GOVERNMENT OF THE DISTRICT OF COLUMBIA  
DEPARTMENT OF TRANSPORTATION

**MEMORANDUM**

**SUBJECT:** BZA Case No. 19841 – 900-914 55<sup>th</sup> Street NE

Figure 1 – Proposed Site Plan (Source: Architectural Plans and Elevations, Sheet 6, undated)

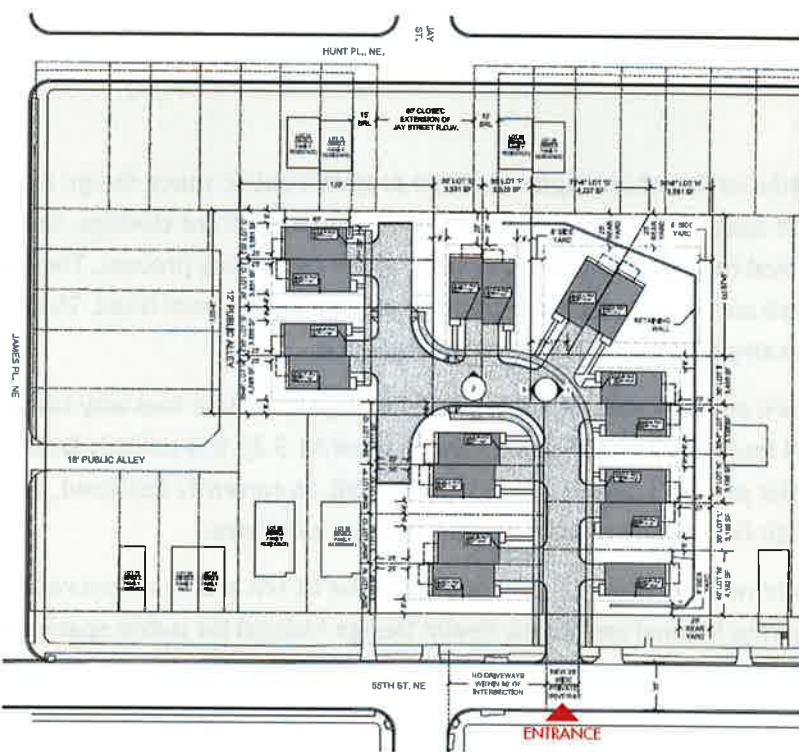
Site access is proposed off of a 20-foot curb cut on 55<sup>th</sup> Street NE to a private driveway. The proposed private driveway will provide access to all 17 units (Figure 1). DDOT typically prefers to allow only one curb cut per site in order to reduce pedestrian and vehicle conflicts and improve pedestrians' experience within public space. However, this Application is for 17 individual, new units, and two curb cuts would be appropriate to improve site and neighborhood circulation by building a missing connection on Jay Street NE. DDOT requested that the Applicants consider two curb cuts: one on Hunt Place NE and another on 55<sup>th</sup> Street NE connecting Jay Street NE through the project. Figure 2 shows a proposal with a Jay Street NE connection while maintaining access to 17 units. DDOT and OP have shared this concept with the Applicant and recommend the Applicant provide a connection, either as a public street or private street with an easement, through the site from 55<sup>th</sup> Street NE to Hunt Place in the approximately location of the missing segment of Jay Street. The Applicant will also need to construct a continuous and uninterrupted sidewalk along each side of the internal street connection between 55<sup>th</sup> Street and Hunt Place to provided adequate pedestrian infrastructure.

Additionally, the curb cuts will need to be designed to accommodate two-way traffic and should be between 18 and 24 feet (Design and Engineering Manual 31.5.2). It is unlikely DDOT will approve public space permits for the project's curb cut on 55<sup>th</sup> Street NE, as currently designed, if the driveway doesn't also connect through the Jay Street right-of-way stub at Hunt Place.

- Provide a connection, either as a public street or private street with an easement, through the site from 55<sup>th</sup> Street NE to Hunt Place in the approximate location of the missing segment of Jay Street; and
- Construct a continuous and uninterrupted sidewalk along each side of the internal street connection between 55<sup>th</sup> Street and Hunt Place.

Figure 2 – DDOT Suggested Site Access Option

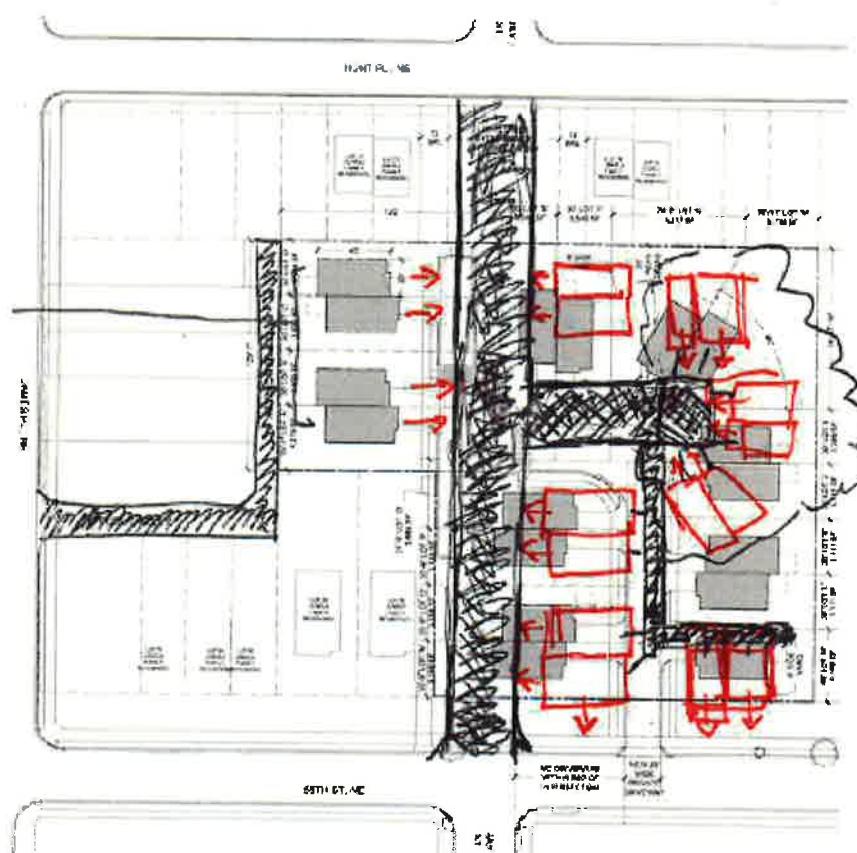
- DDOT's preference is for Jay Street to be constructed as a public roadway in a straight line across the site as shown in Figure 2 below. However, DDOT is amenable to other designs and public/private arrangement so long as the connection across the site is made in the approximately location of the missing segment of Jay Street;
